Inspection Report

Station: Mitchell Unit: 1 Report Name: 1-WATER WALL FRONT

AREA: Water Wall Front

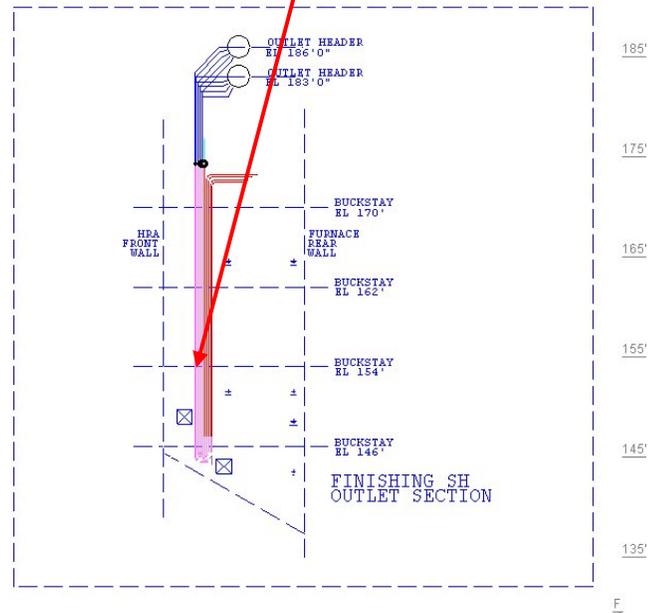
Apply 2"x3" pad-weld to the abrasions caused by the slip spacers, and re-attach the broken/missing slip spacers on the following:

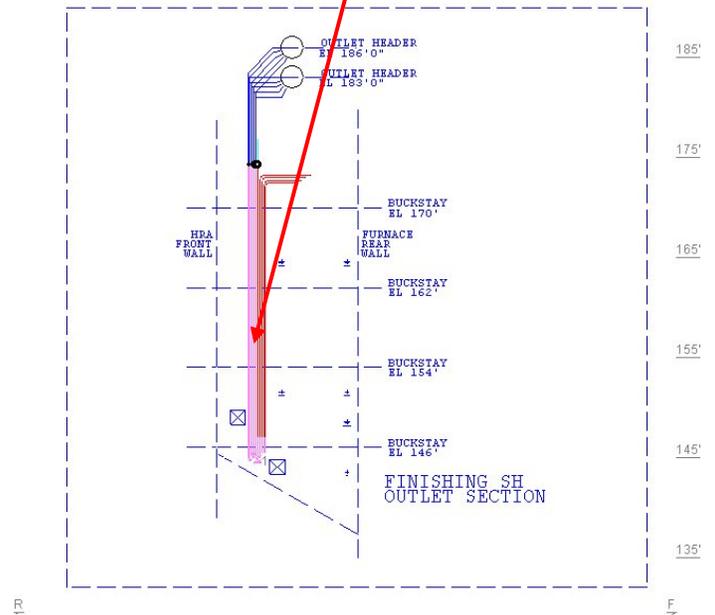
Replace missing/broken Ring Castings (handcuffs). Approximately 20% of the Handcuffs are missing/broken in this area and need to be replaced to prevent from any further alignment issues in this area.

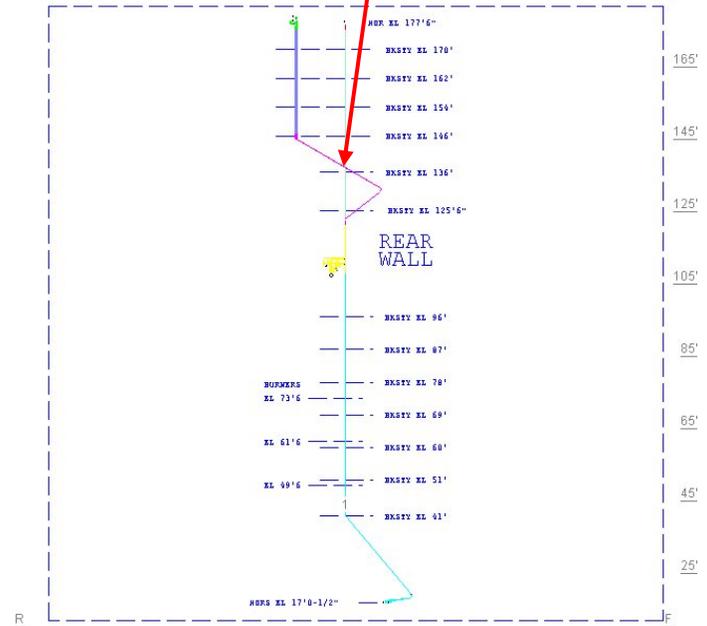
201/0.195", 202/0.189", 203/0.193"

204/0.183", 205/0.173", 206/0.174"

207/0.162", 208/0.143", 209/0.154"

210/0.169", 211/0.160", 212/0.166"

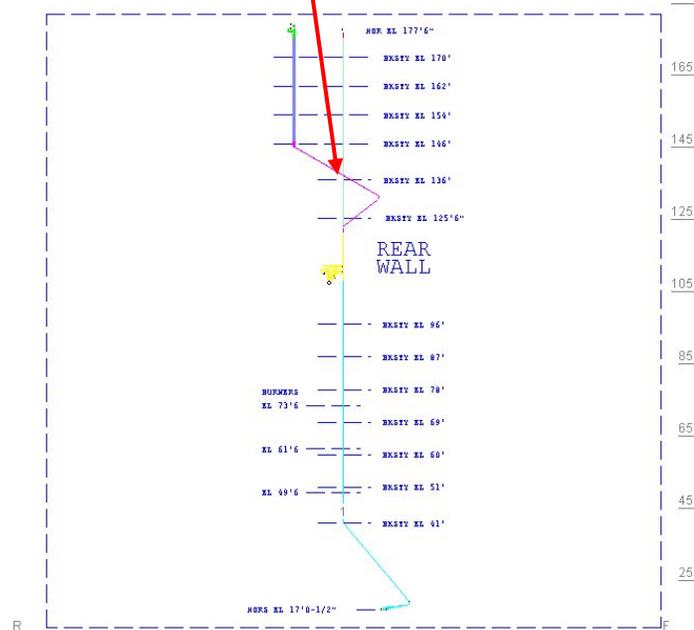
Apply 24" pad welds to the following arch
tubes (UT) due to sootblower erosion:

196(.236), 197(.222), 198(.214)

199(.209), 200(.215), 240(.238)

248(.210), 249(.213), 250(.221)

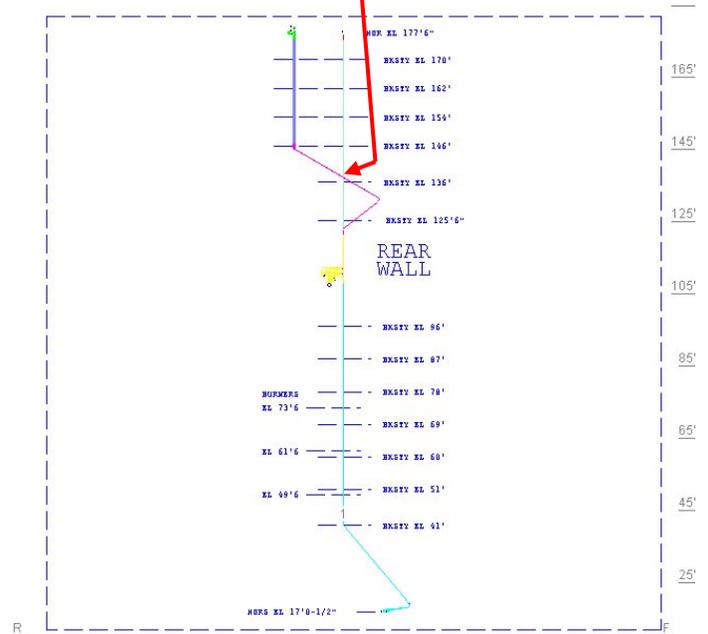
Install refractory at the base of all support tubes above the arch penetration to provide erosion and fallen ash resistance.

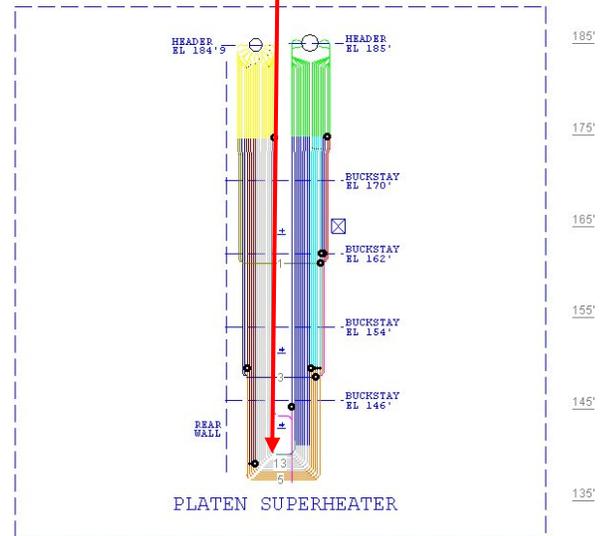
Install approximately 10' dutchman to the eroded area. The eroded area is at the front inner radius bend on **17F**. It is recommended to replace the entire lower loop of **tube 17** approximately 4' up on either side.

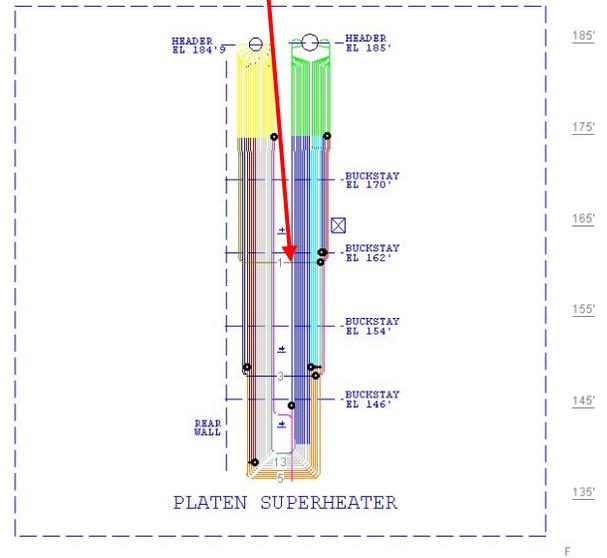
Apply 18"x3" Pad-Weld to the top edge of the horizontal section of the wrapper tube #1 due to soot blower erosion:

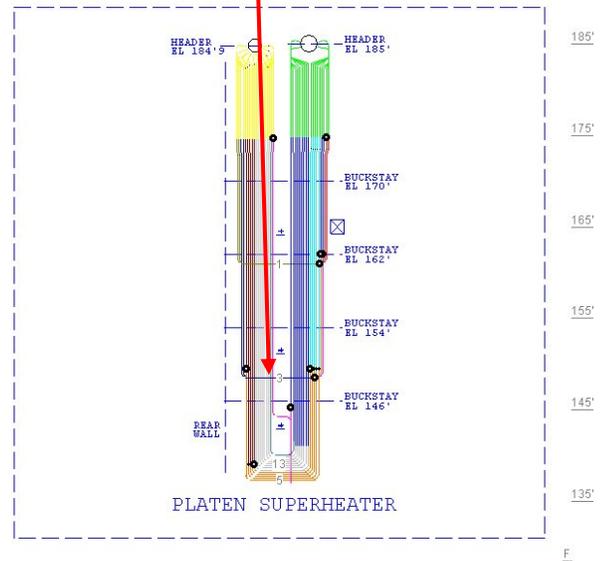
Apply approximately 3" x 2" pad welds to the following platens/ tubes/ UT readings:

23/ 3R/ 0.452"

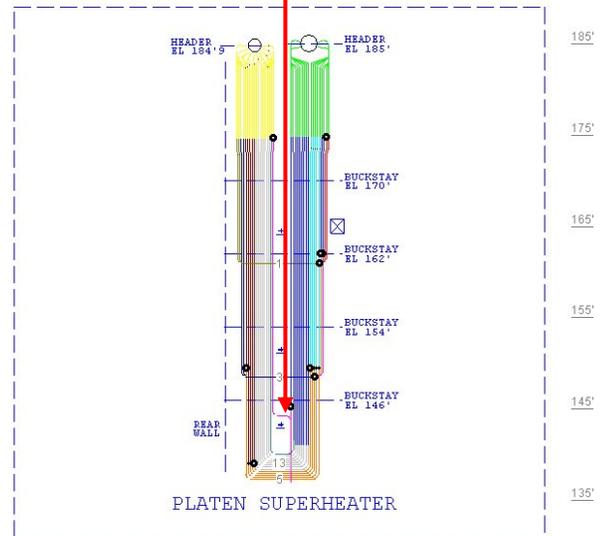
Due to excessive bowing, plan for future
replacement Tube 18R at Assembly 23.

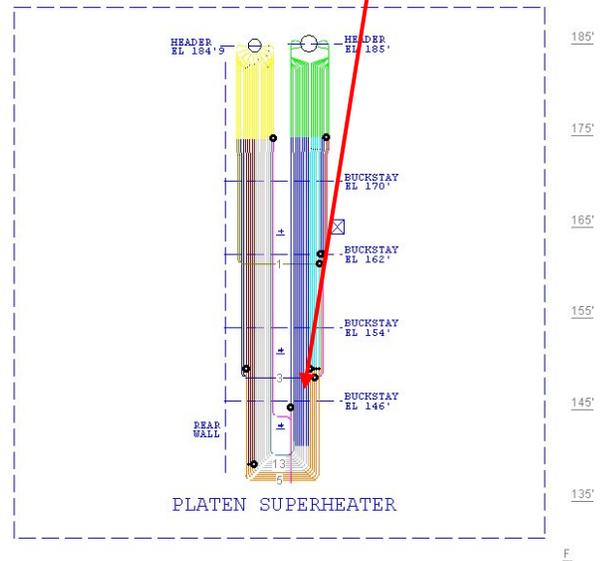
Re-align the following platens/ tubes at the following locations:

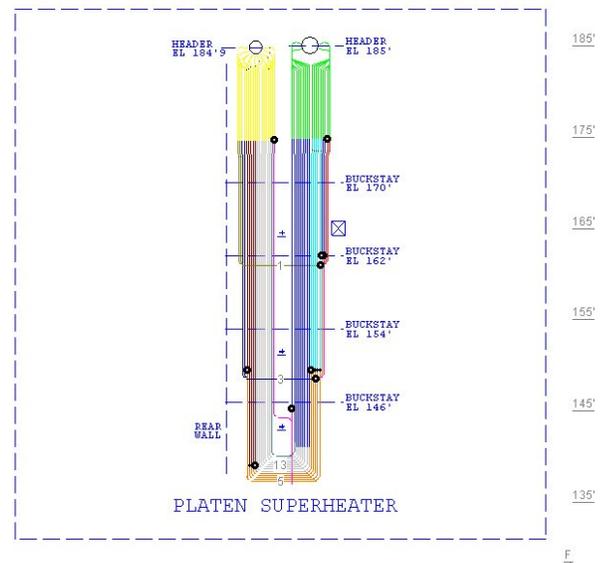
Replace Refractory on *IK's 1-6* due to missing/broken Refractory.
